APP-GW-GLR-079-NS, Revision 0

“AP1000 Verification of Water Sources for Long-Term Recirculation Cooling Following a LOCA”

AP1000 Standard Combined License Technical Report

Attachment A

**Table 2.2.3-4 (cont.)
Inspections, Tests, Analyses, and Acceptance Criteria**

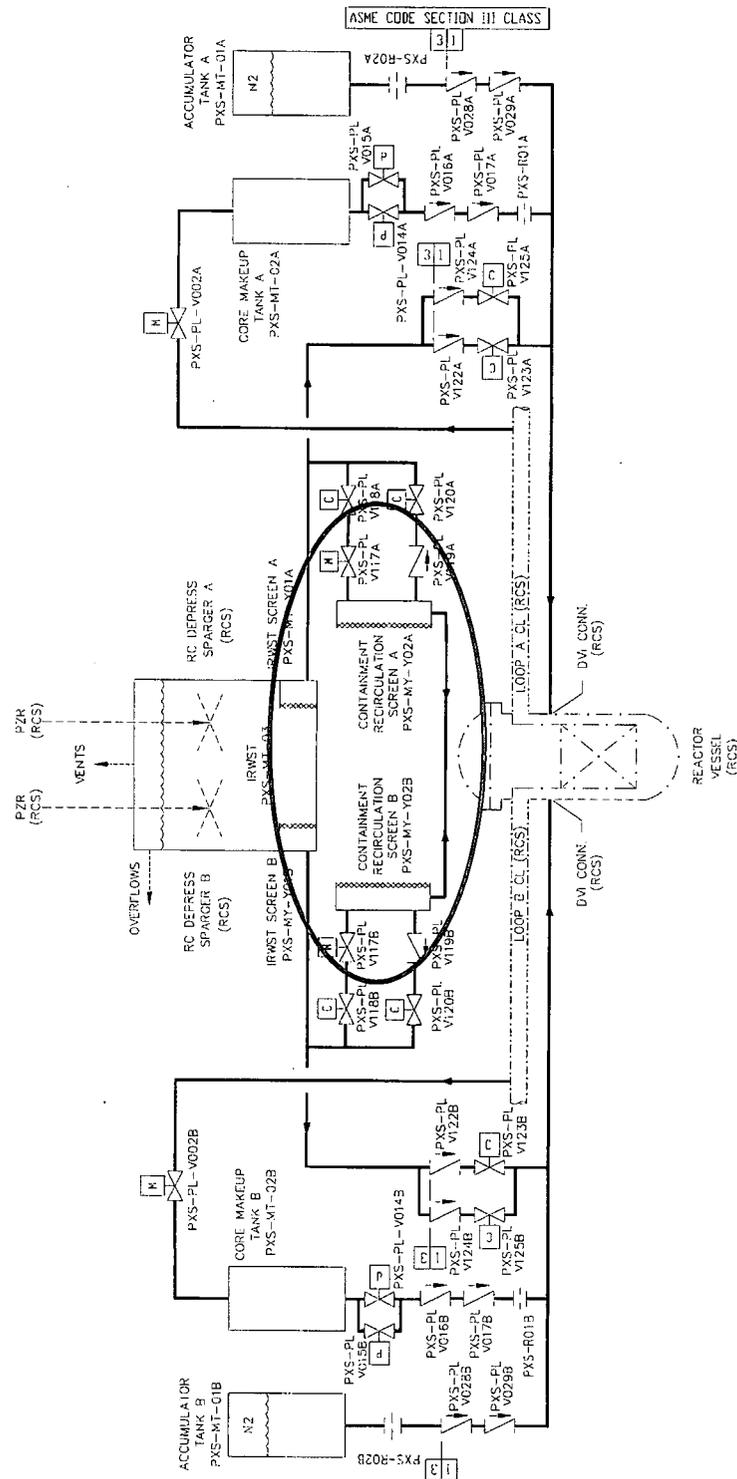
Design Commitment	Inspections, Tests, Analyses	Acceptance Criteria
	<p>vii) Inspection of the as-built components will be conducted for plates located above the containment recirculation screens.</p> <p>viii) Inspections of the IRWST and containment recirculation screens will be conducted.</p> <p>ix) Inspections will be conducted of the insulation used inside the containment on ASME Class 1 lines and on the reactor vessel, reactor coolant pumps, pressurizer and steam generators.</p> <p>x) Inspections will be conducted of the as-built nonsafety-related coatings or of plant records of the nonsafety-related coatings used inside containment on walls, floors, ceilings, structural steel which is part of the building structure and on the polar crane.</p> <p>xi) Inspection of the as-built CMT inlet diffuser will be conducted.</p> <p>xii) Inspections will be conducted of the CMT level sensors (PSX-11A/B/D/C, - 12A/B/C/D, - 13A/B/C/D, - 14A/B/C/D) upper level tap lines.</p>	<p>vii) Plates located above each containment recirculation screen are no more than 1 ft above the top of the screen and extend out at least 10 ft perpendicular to and at least 7 ft to the side of the trash rack portion of the screen <u>surface</u>.</p> <p>viii) The screen surface area (width x height) of each screen trash rack is $\geq 70 \text{ ft}^2$ and of each fine IRWST screen is $\geq 40 \text{ 500 ft}^2$ (unfolded area). <u>The screen surface area of each containment recirculation screen is $> 2500 \text{ ft}^2$.</u> The bottom of the containment recirculation screens is ≥ 2 ft above the loop compartment floor.</p> <p>ix) The type of insulation used on these lines and equipment is a metal reflective type or a suitable equivalent.</p> <p>x) A report exists and concludes that the coatings used on these surfaces has a dry film density of $\geq 100 \text{ lb/ft}^3$.</p> <p>xi) The CMT inlet diffuser has a flow area $\geq 165 \text{ in}^2$.</p> <p>xii) The centerline of each upper level tap line at the tee for each level sensor is located $1" \pm 1"$ below the centerline of the upper level tap connection to the CMT.</p>

DCD Figure 2.2.3-1 (Sheet 2 of 2)
 Passive Core Cooling System

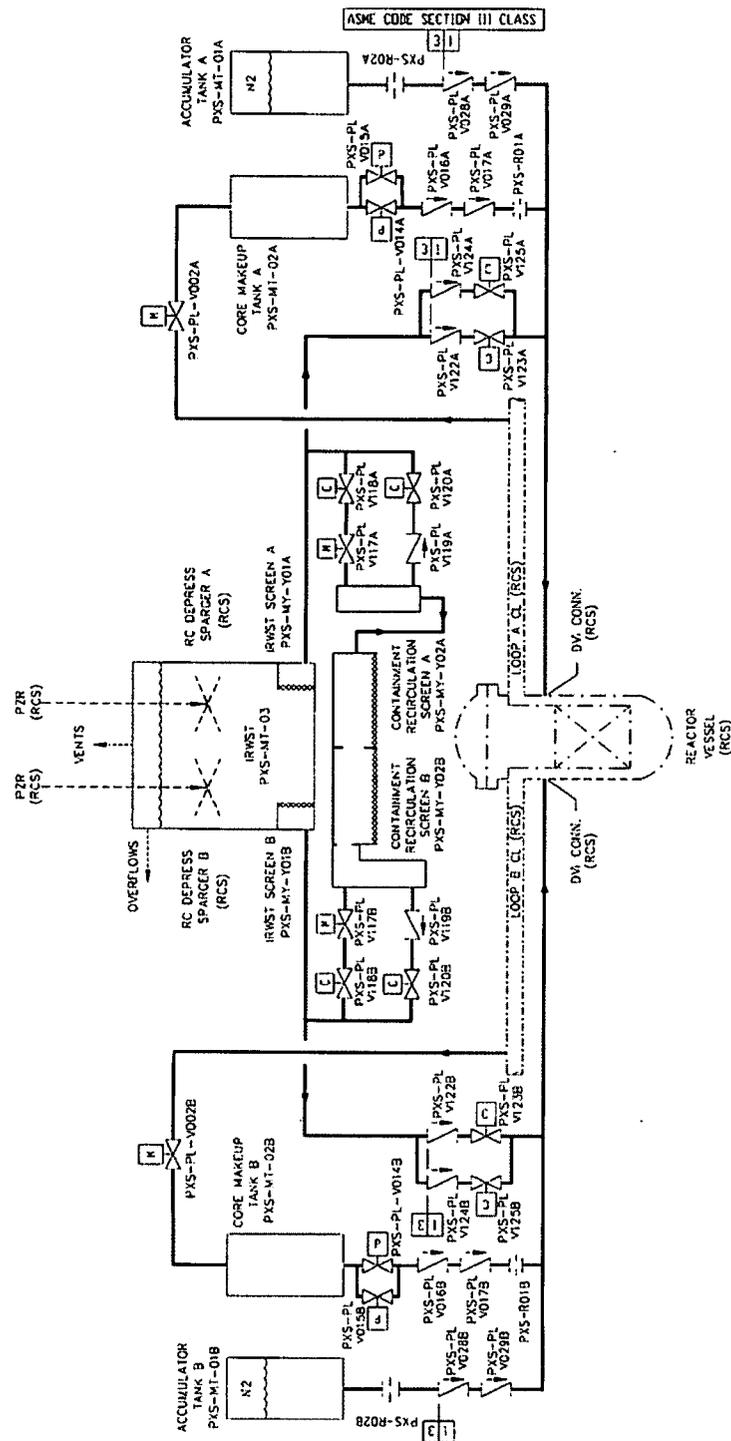
Current DCD Figure Showing Area to be Revised

Revised DCD Figure

Figure 1.2-9
**Nuclear Island General Arrangement
Plan at Elevation 117'-6" with Equipment**

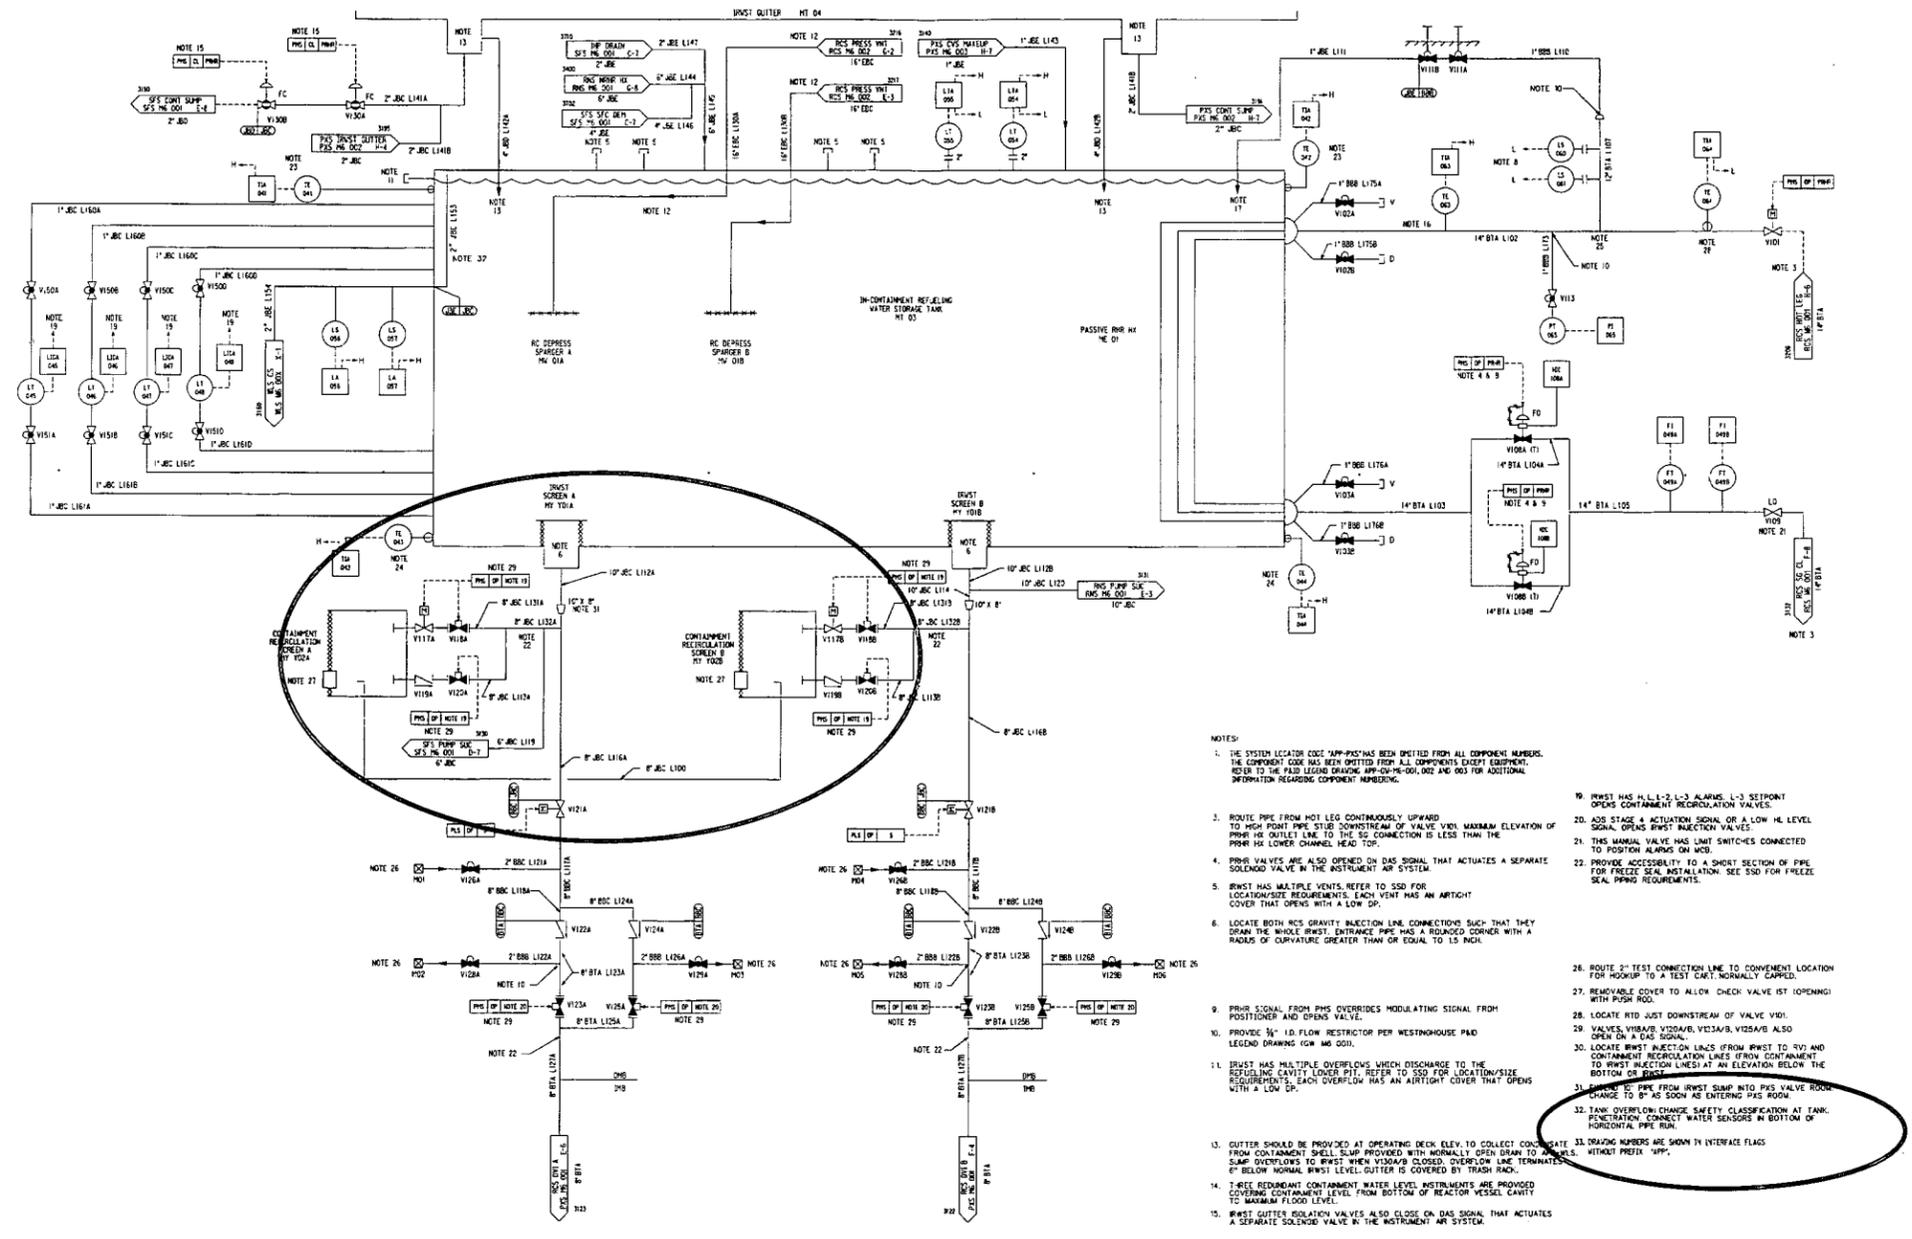
Revised DCD Figure

Figure 6.3-2
Passive Core Cooling System
Piping and Instrumentation Diagram (Sheet 2)

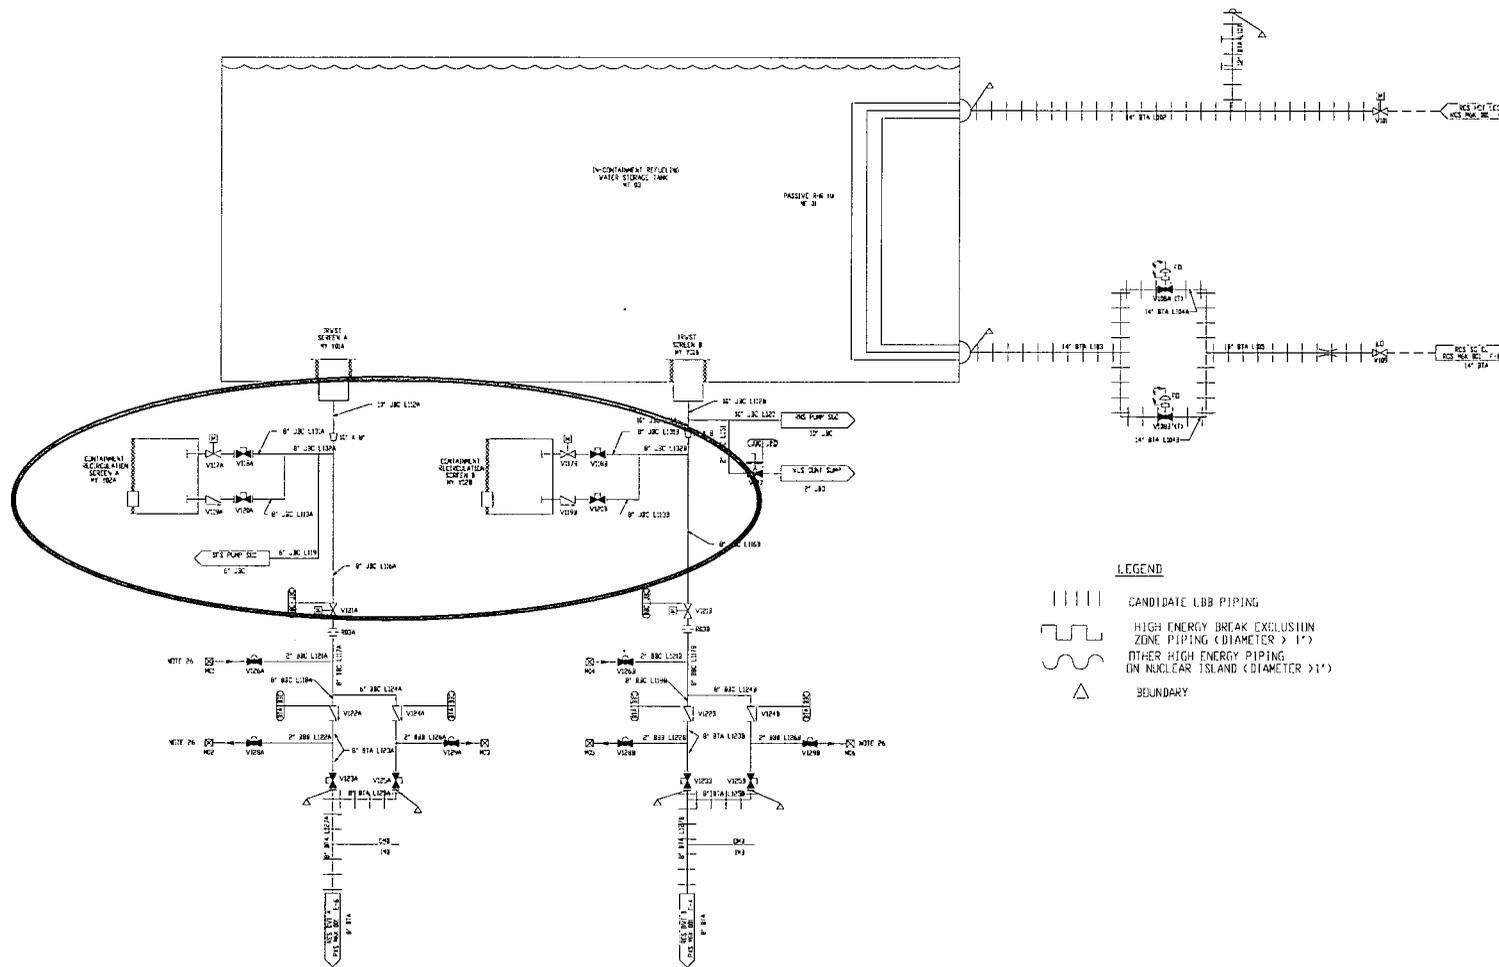
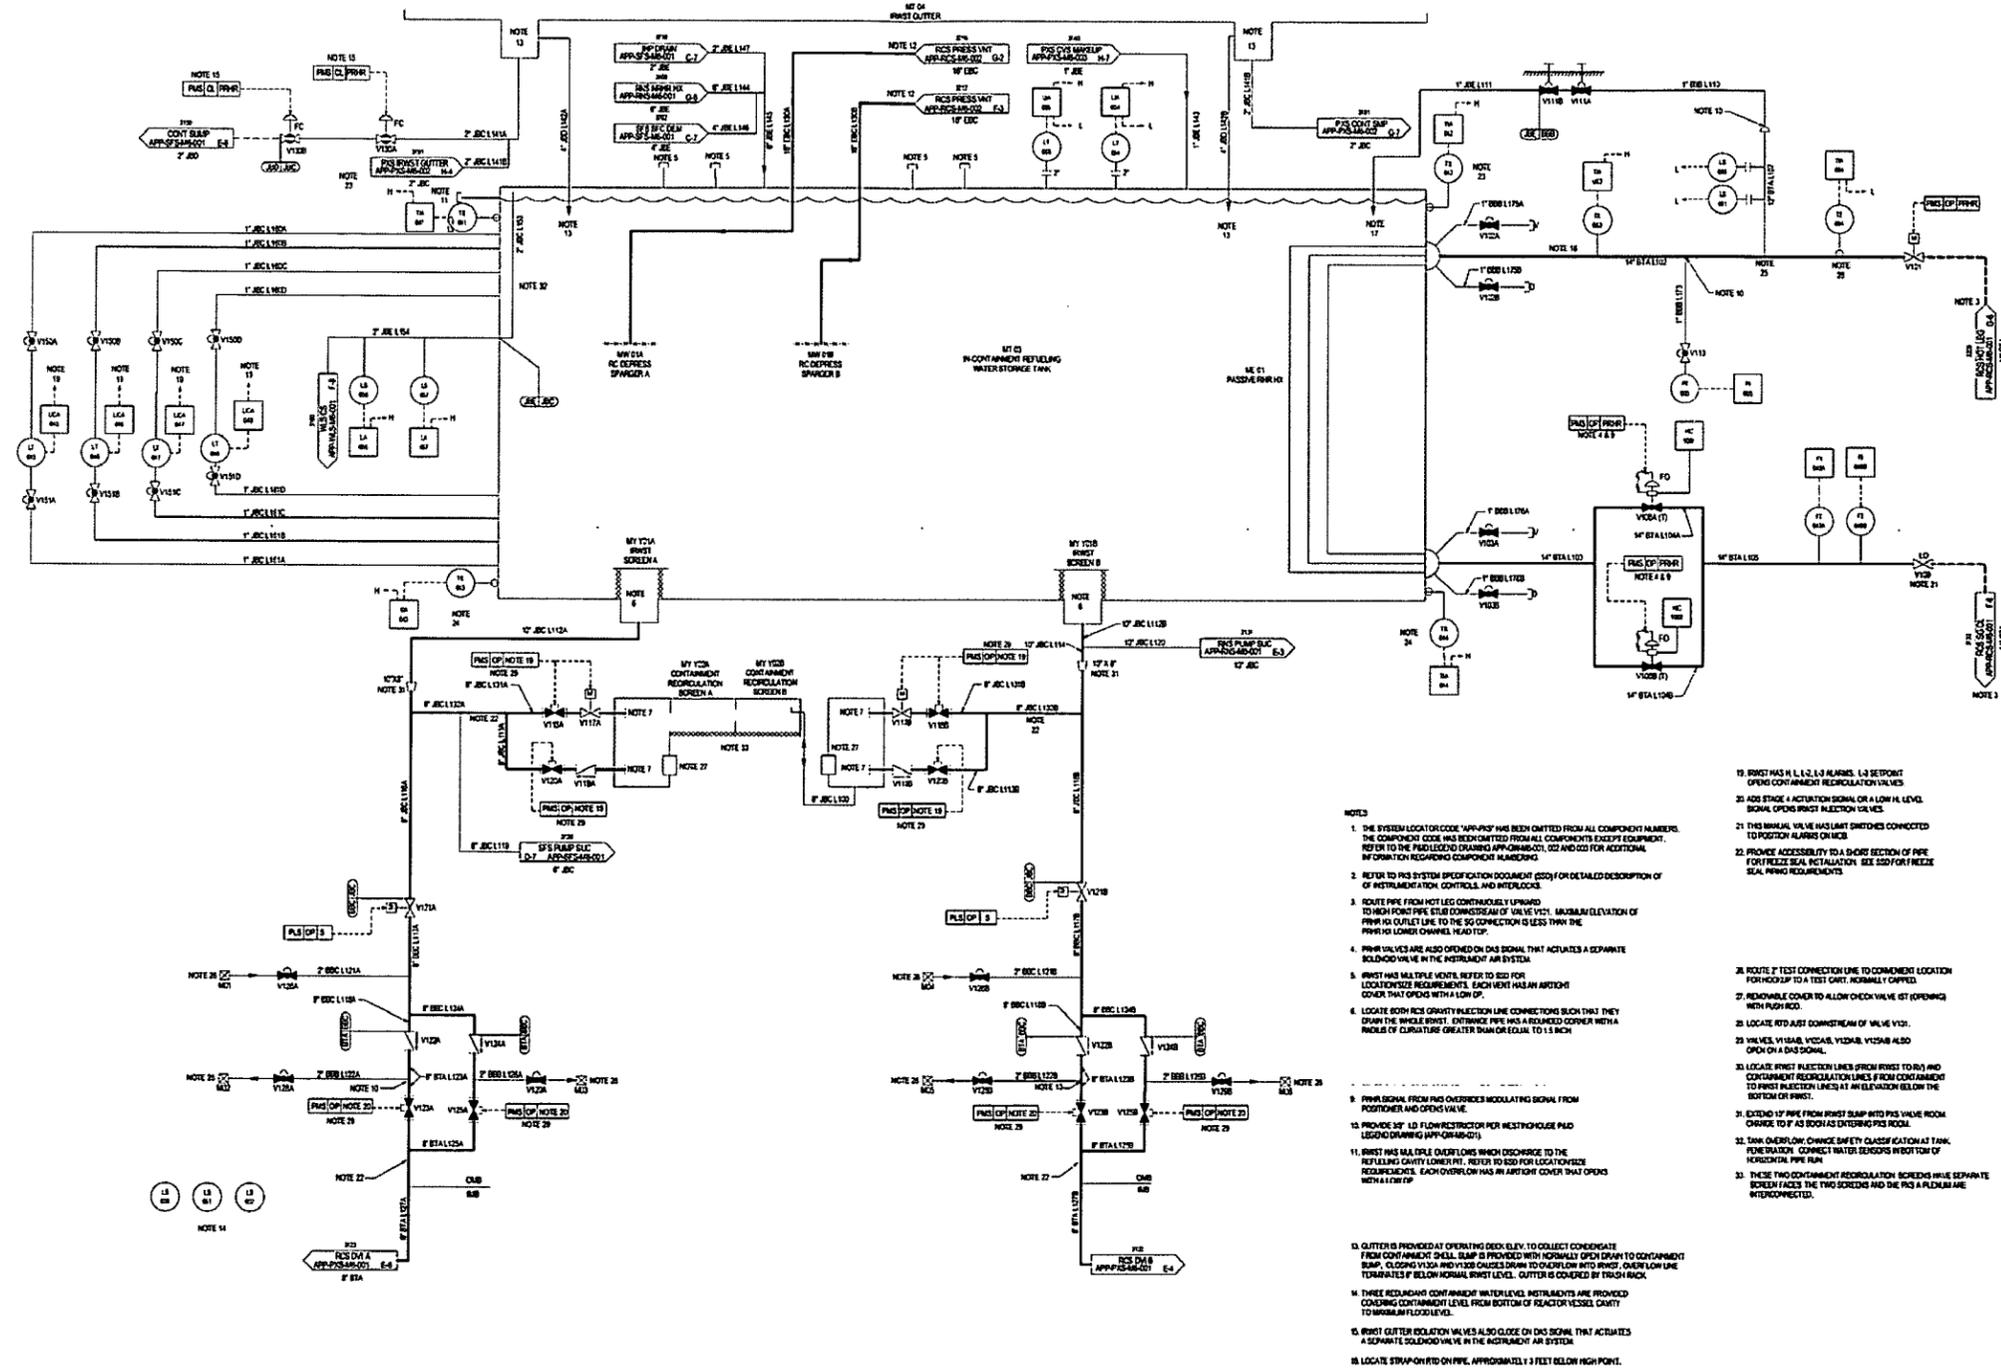
Current DCD Figure Showing Areas to be Revised

Modifications in indicated area same as modifications to Figure 6.3-2

Revised DCD Figure

Figure 9A-1 (Sheet 4 of 16)

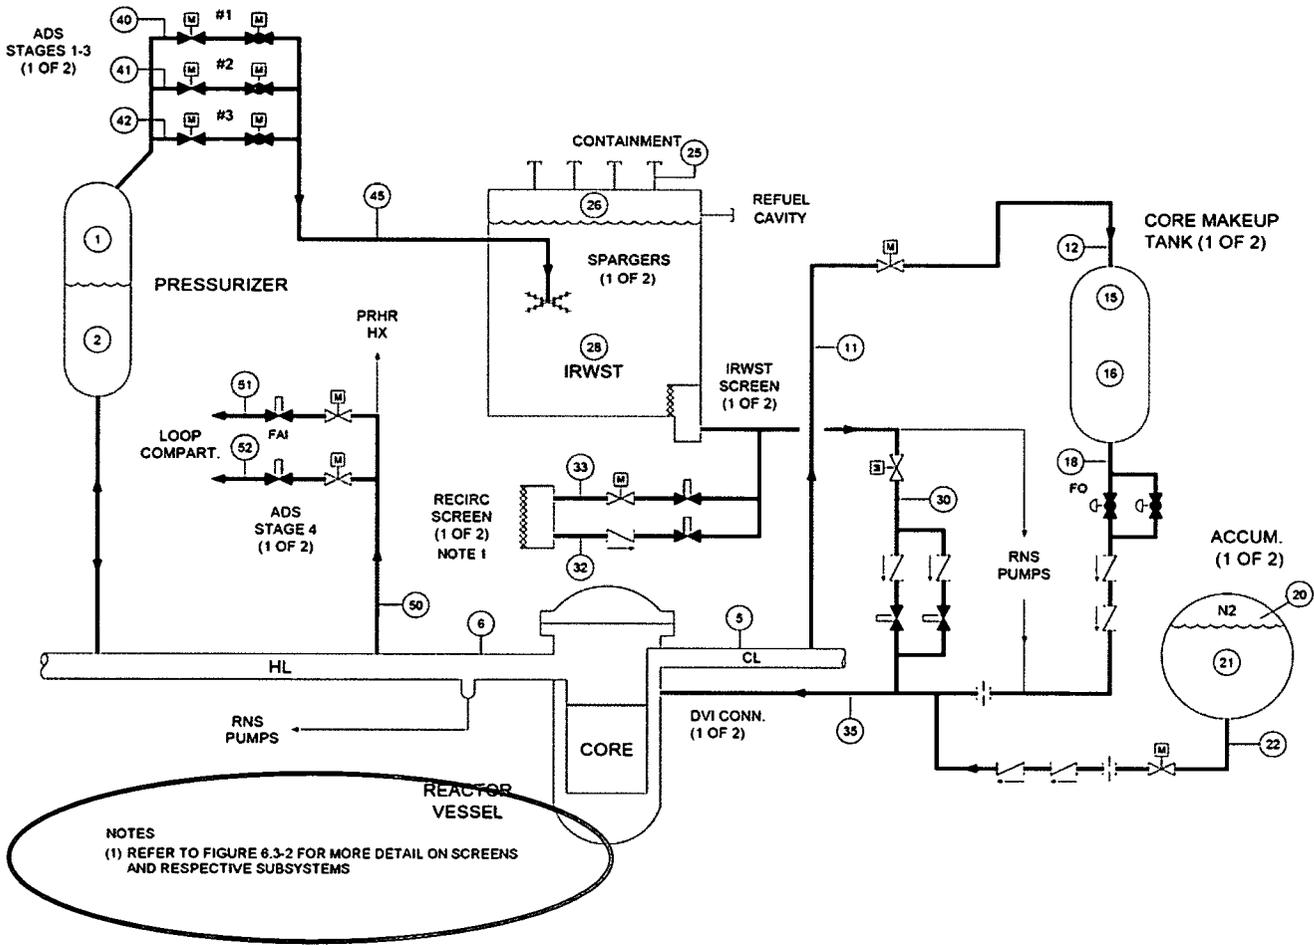
Current DCD Figure Showing Area to be Revised

Revised DCD Figure with addition circled.
